RESH ROAD LANDFILL PHASE II
CLOSURE CAP DESIGN
LANDFILL GAS SYSTEM PLAN

SHEET NO.
C-11 REV.

RESH ROAD LANDFILL PHASE II CLOSURE CAP DESIGN
LANDFILL GAS SYSTEM DETAILS I

SHEET NO.
C-12

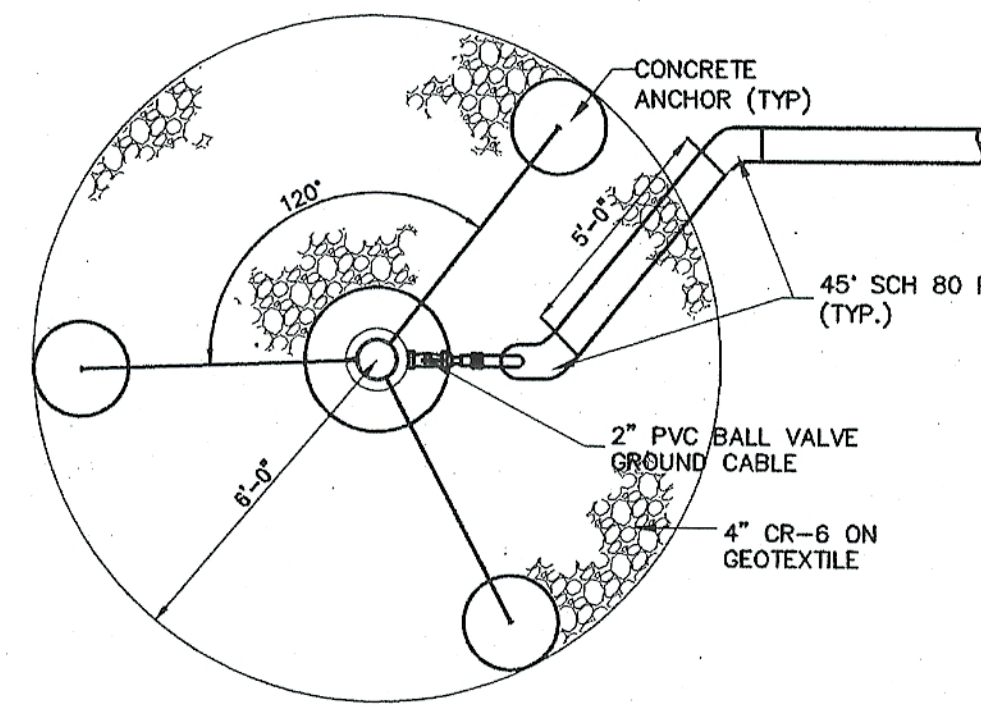
Note for potential conversion to active system:
W-46 appears to slope towards the
valve assembly at the main header pipe.

LANDFILL GAS WELL DETAIL

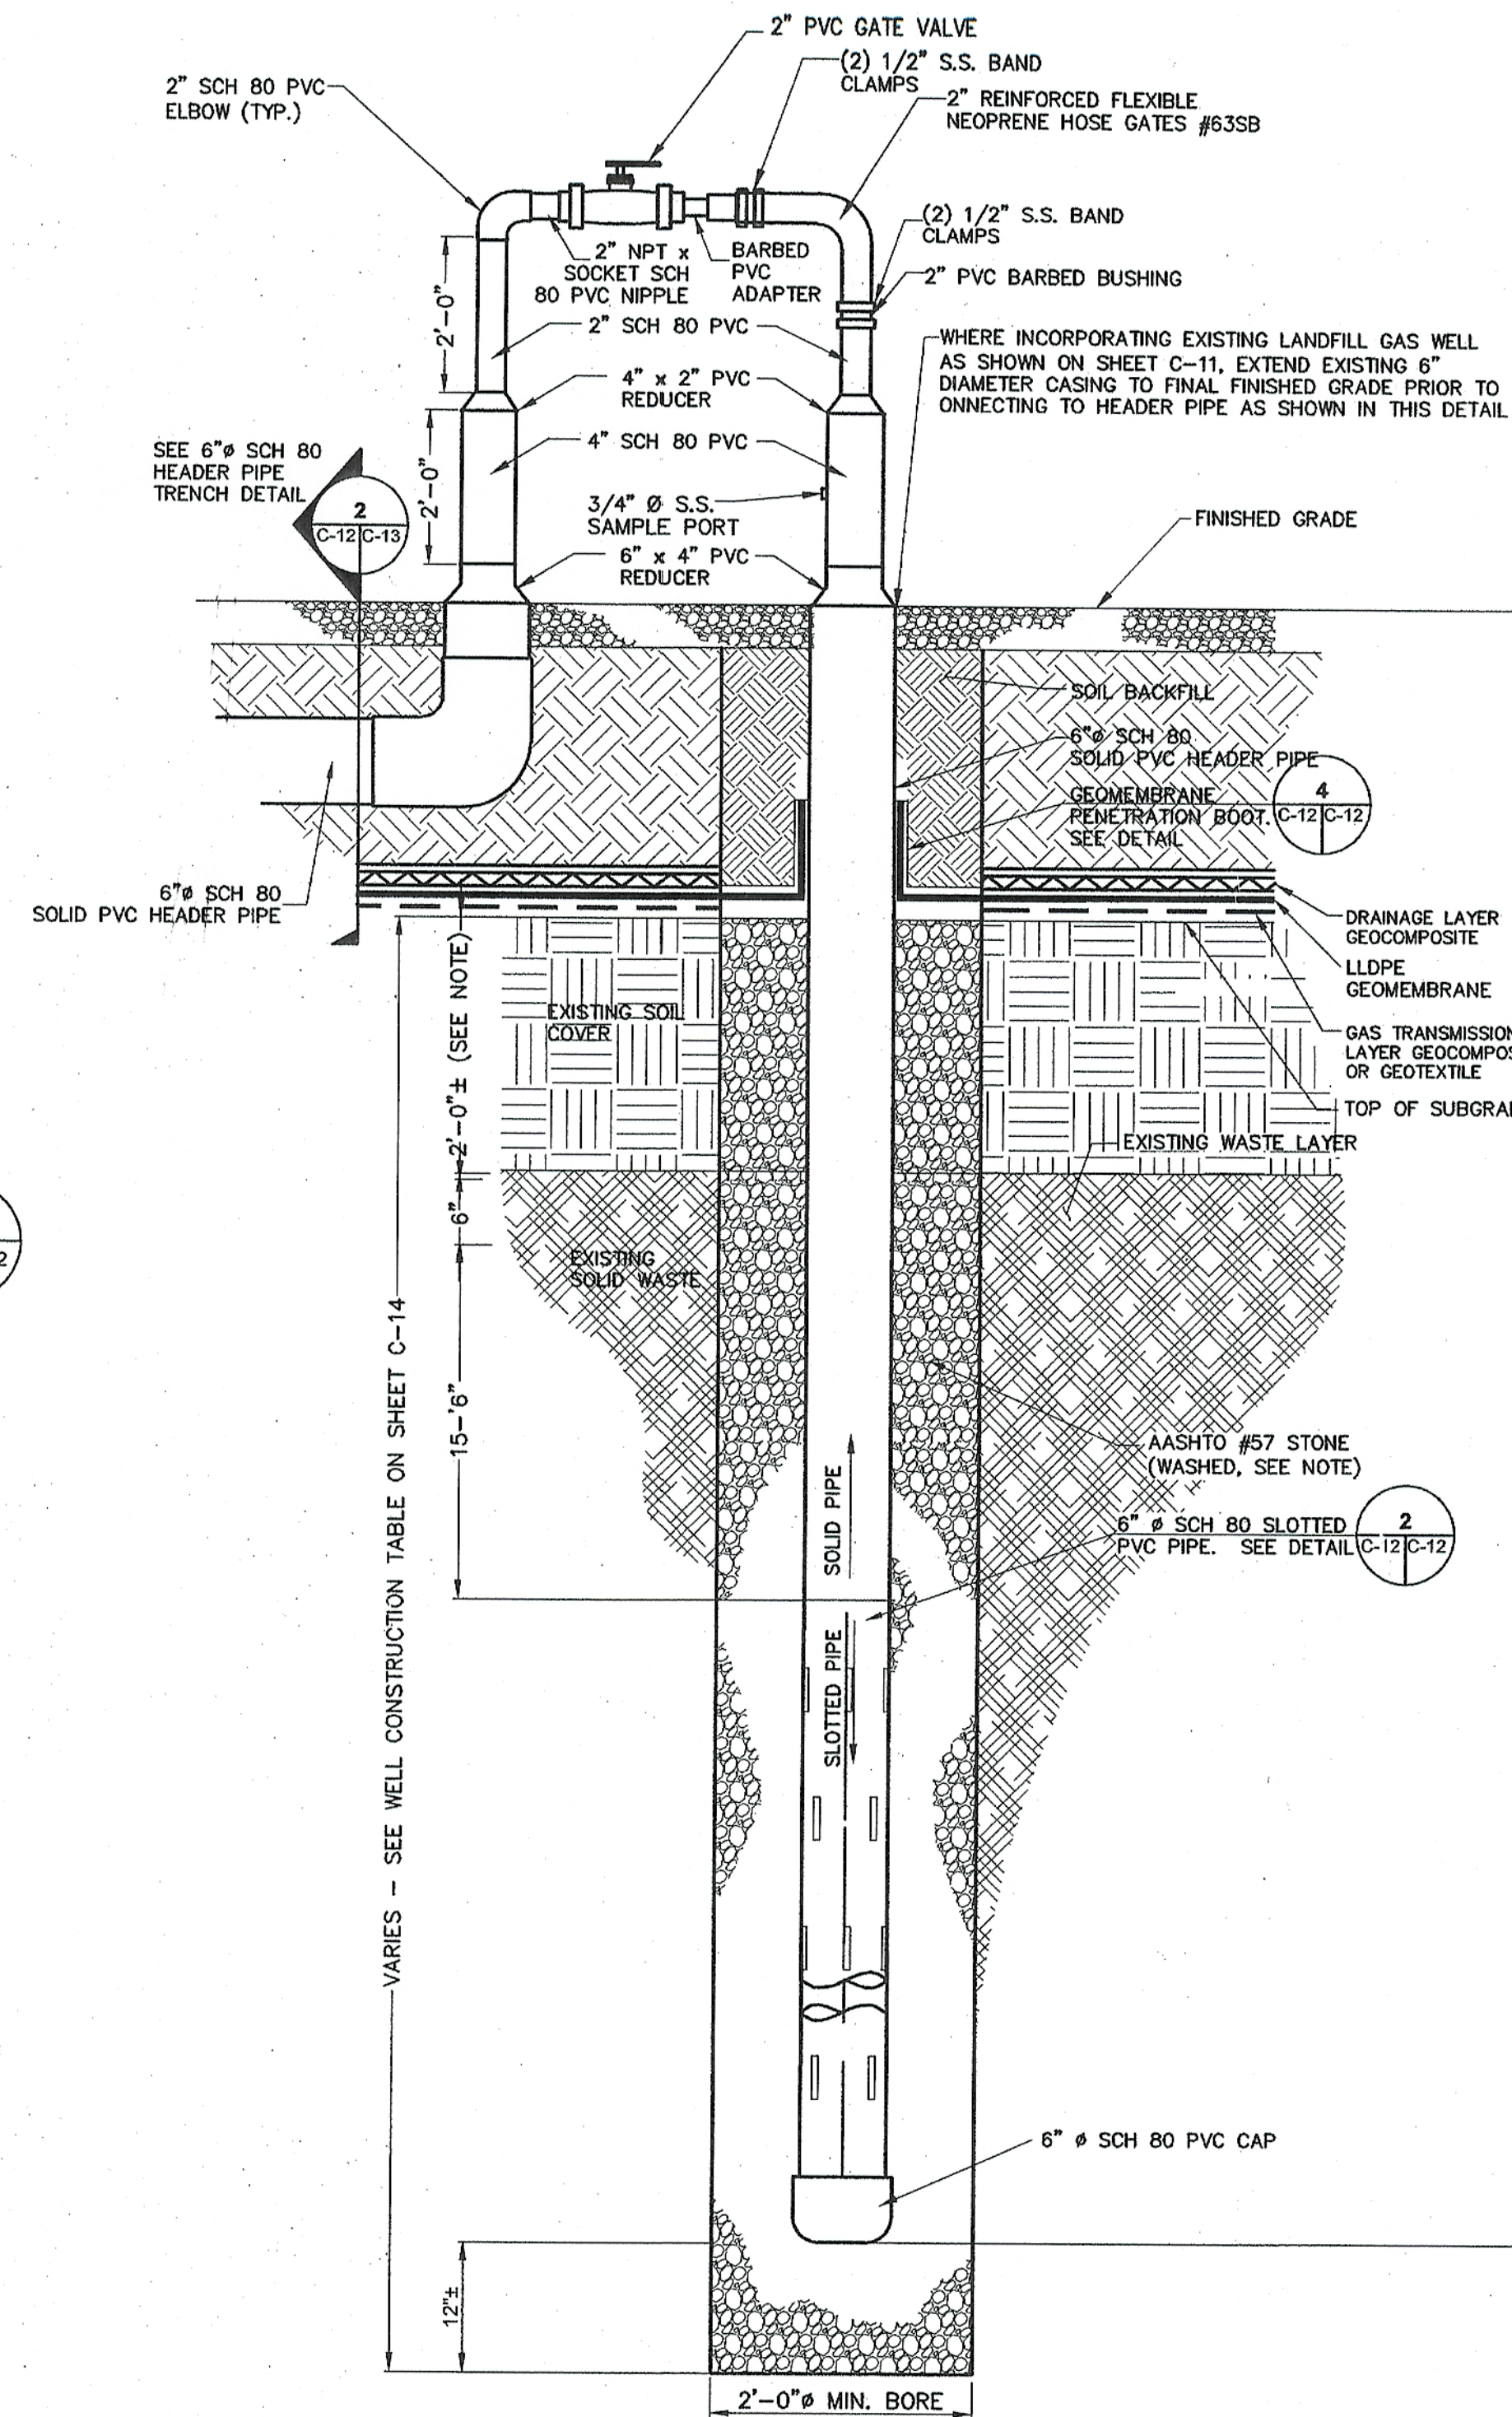
- Add Revised Detail 5
- Note the elimination of flare systems

LANDFILL GAS WELL DETAIL

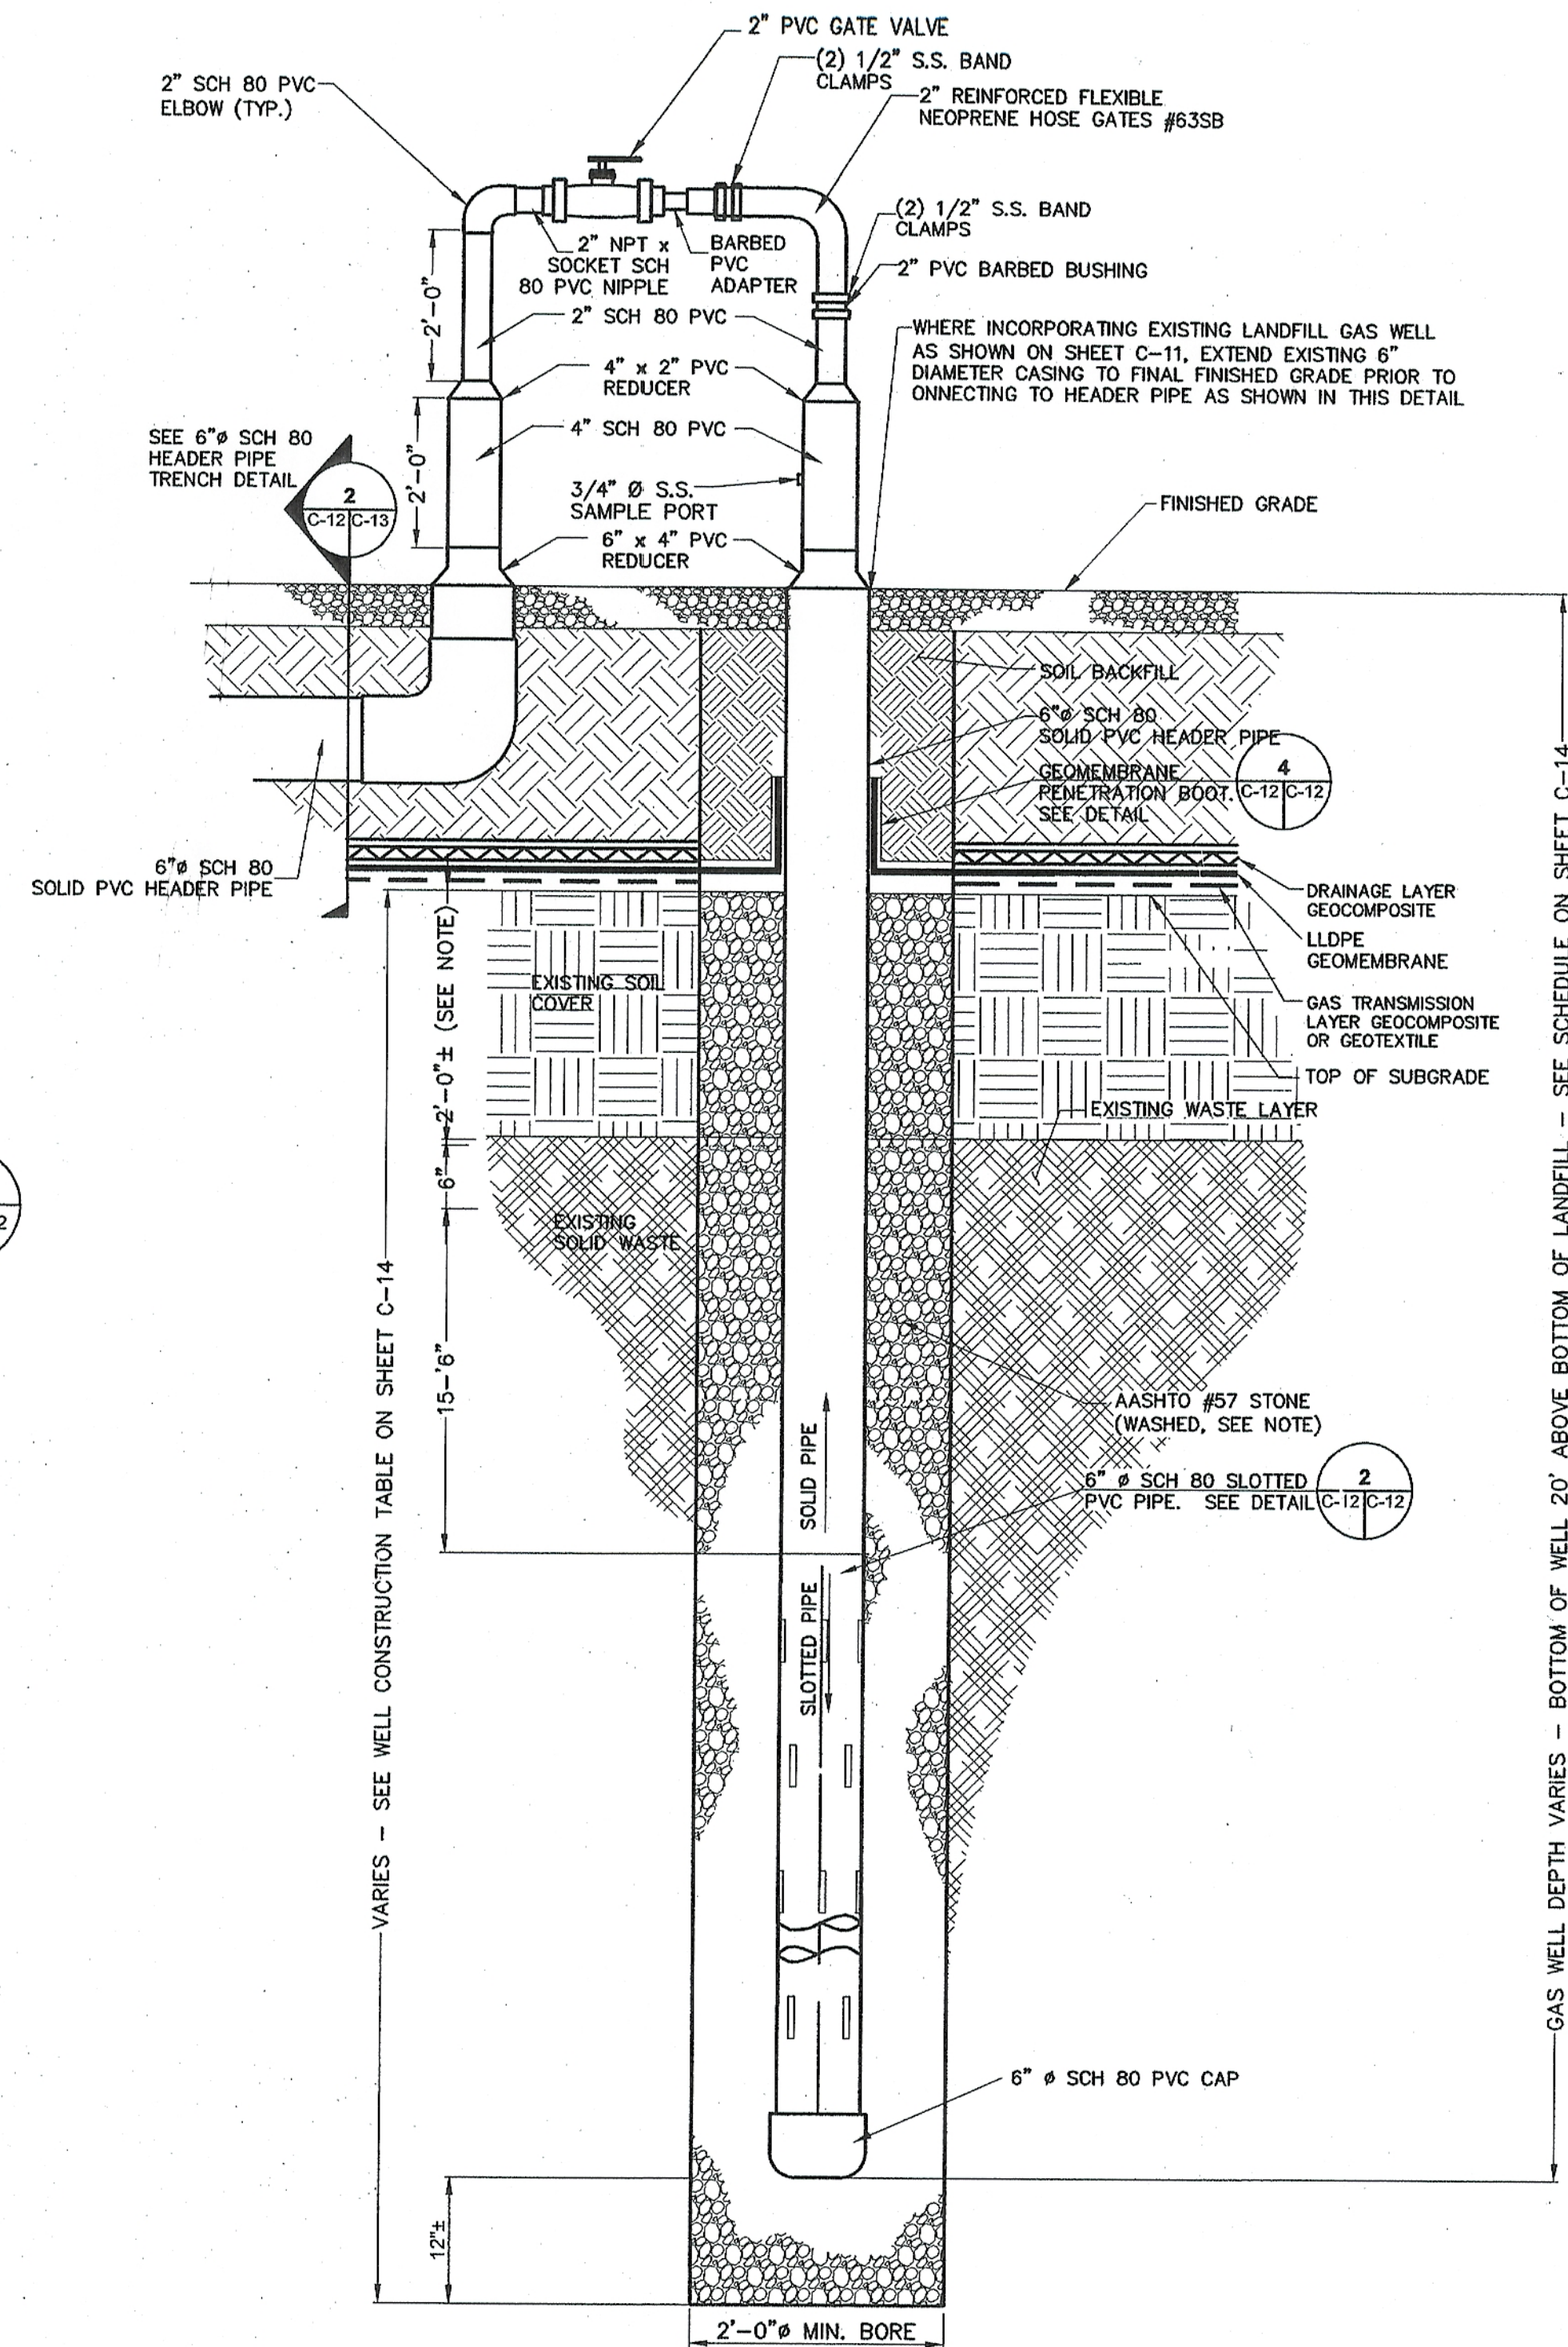
- Add Revised Detail 5
- Note the elimination of Flore systems

WASHED STONE
THE AASHTO #57 STONE USED IN THE LANDFILL GAS WELLS AND LATERAL TRENCHES SHALL BE WASHED PER AASHTO T11 AND CONTAIN LESS THAN 1.50% MATERIALS FINER THAN THE NO. 200 SIEVE.
